**RE:** **The Net**  
**Geotechnical Recommendations for Rubble Berm Support of Basement Walls**  
19567-01

Re: **Plan Review and Minimum Risk Statement**  
**The Net - 801 3<sup>rd</sup> Avenue Demolition**  
**Seattle, Washington**  
19567-01

This letter provides Hart Crowser's geotechnical-related review of the structural submittal for temporary support of existing basement walls during demolition.

**Re: Addendum #2 – Supplementary Recommendations  
The NET - 801 3<sup>rd</sup> Avenue Demolition  
Seattle, Washington  
19567-01**

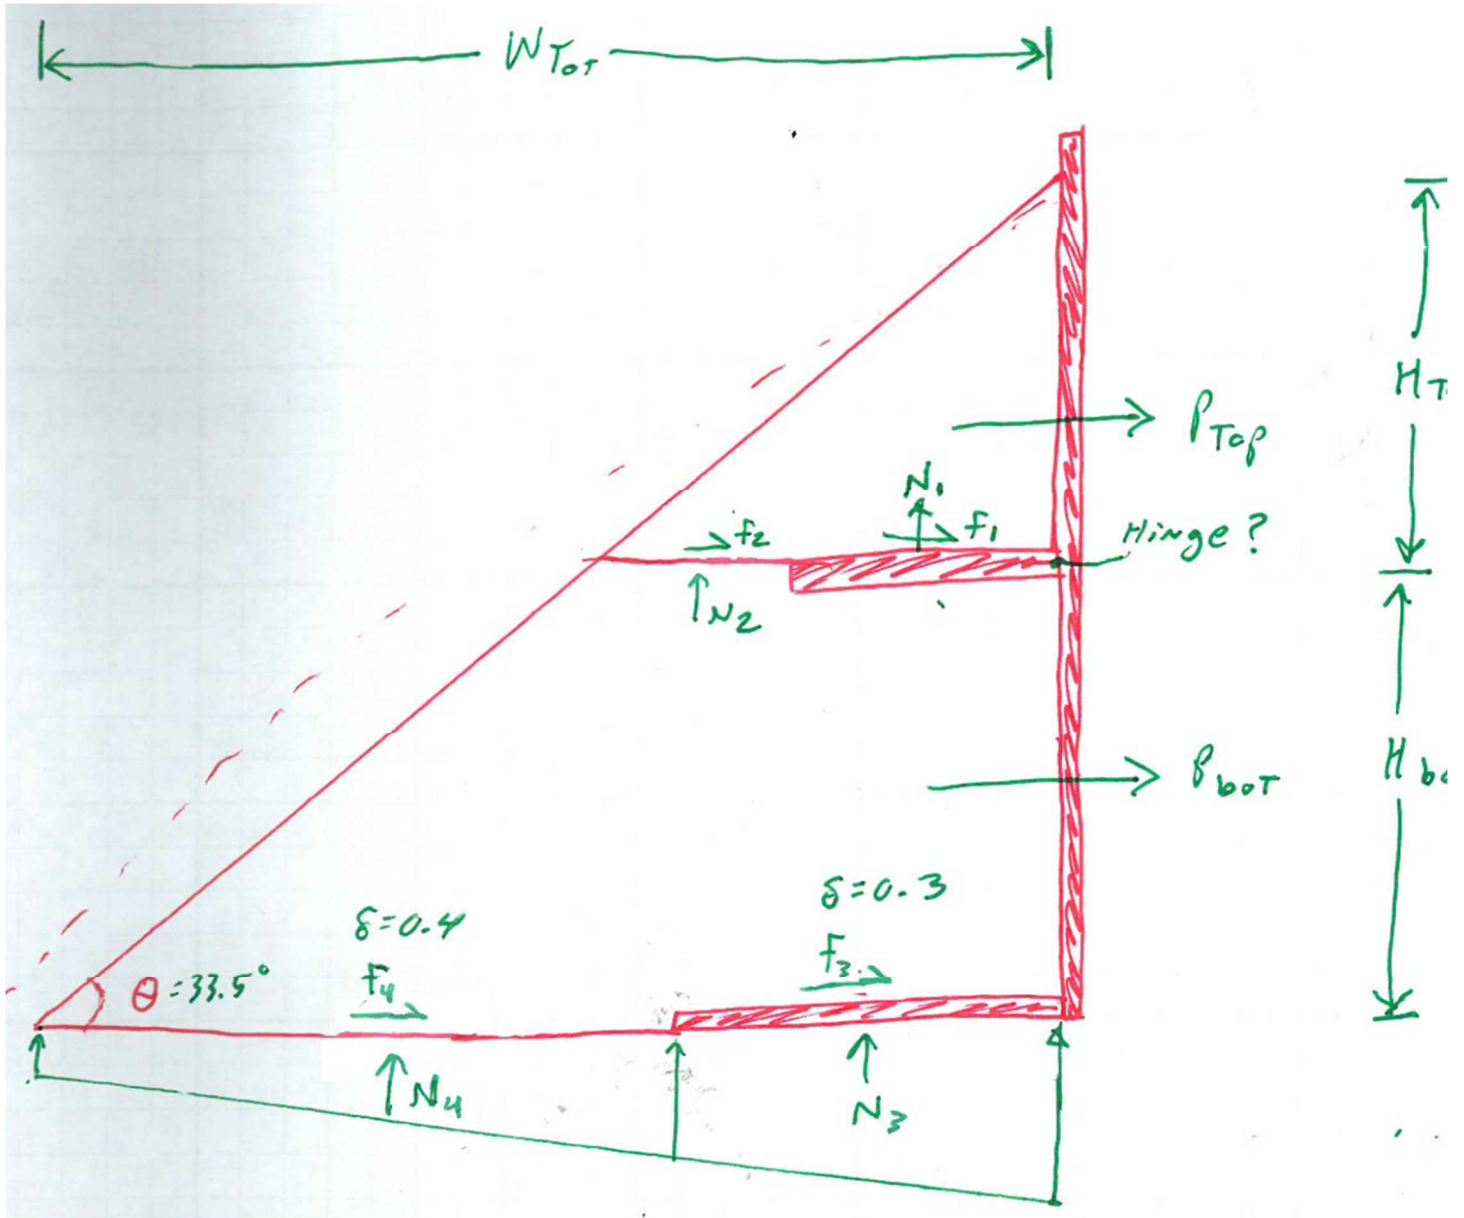
For CDF filling the voids in rubble, for 100% void space filled, the total volume could consist of about 50% concrete + 50% CDF; for an average unit weight of  $(110+140)/2 = 125$  pcf. In reality, it will not be 100% void spaced filled with CDF... so, maybe you only get 115 to 120 pcf modified unit weight...

Regarding the effect of an intermediate slab within the berm. If we push to the left at the top of the wall with a max force of  $P_{top}$ , can the wall transmit the force further down, or will it hinge at the location of the intermediate slab?

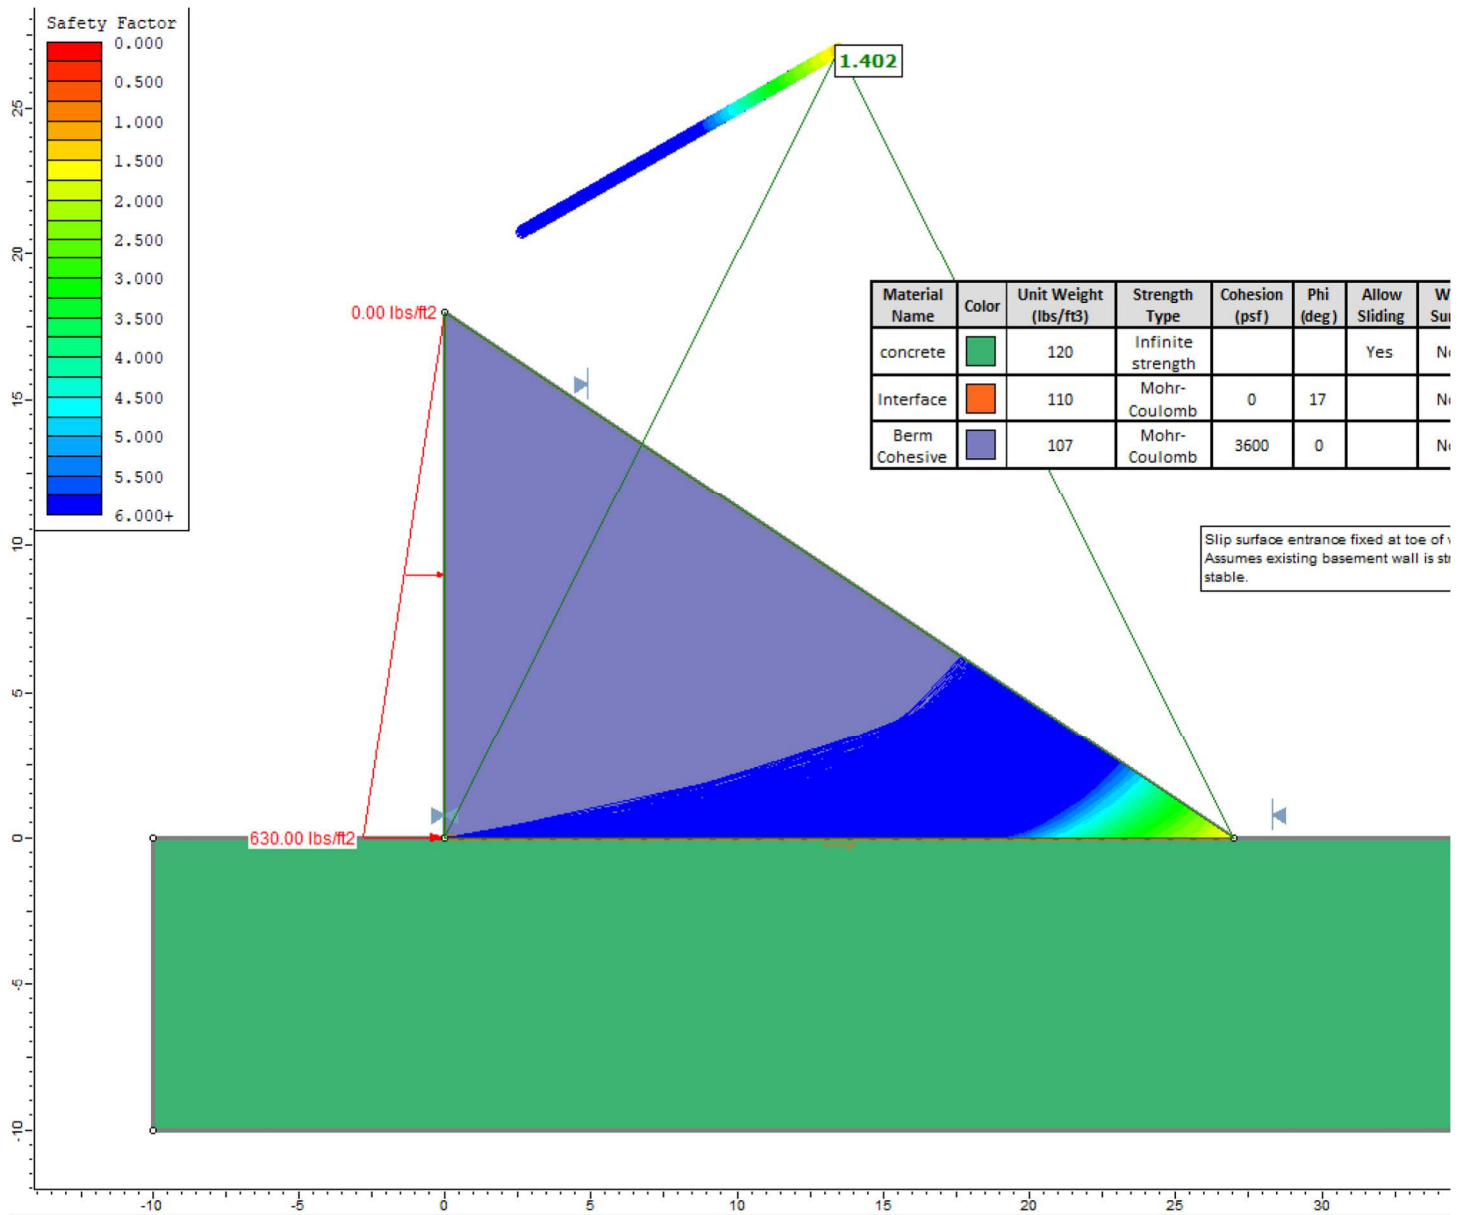
For CDF placed on the existing concrete floor slabs, we recommend using the same ultimate base sliding interface friction as for the rubble ballast material (friction factor = 0.3, or friction angle of 17 degrees).

Based on the Stoneway mix design data sheets provided by LCL, for the Flowable CDF, the design unit weight varied from 107 to 112 pcf. We recommend assuming the design unit weight of 107 pcf for the flowable CDF. For the stackable CDF, the design unit weight was 130 pcf for the two data sheets provided by LCL. We recommend a design unit weight of 130 pcf for the stackable CDF.
